Heavy Duty Slider Base Product Update

Part Number: FWS2

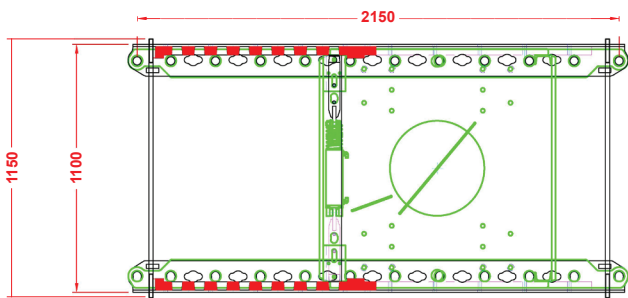
Effective 1st February 2020, all assemblies comprising of 'FWS2' heavy duty sliders will be supplied with SAF-HOLLAND ISO bolt on Feet only, as per supplier recommendation.

Please note: Due to the bolt-on feet, the overall height of the fifth wheel assembly will increase by 12 mm.

Part Description: Heavy Duty Turntable Slider, Standard Option, 700 mm Travel 100 mm increments, 270 kN D-Value

Part Number: FWS

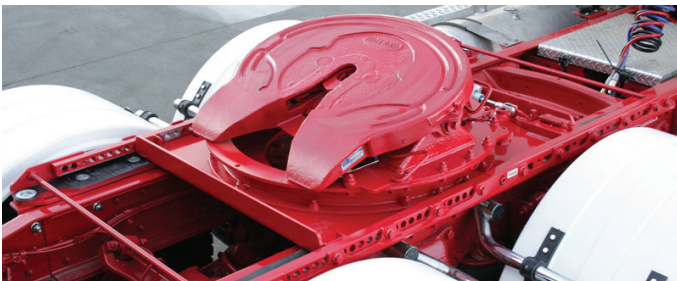
In addition to the above, there will be another heavy duty slider available for sale, specifically to suit ballrace fifth wheel assemblies.

Part Description: Heavy Duty Turntable Slider, Ballrace Option, 700 mm Travel 100 mm increments, 270 kN D-Value
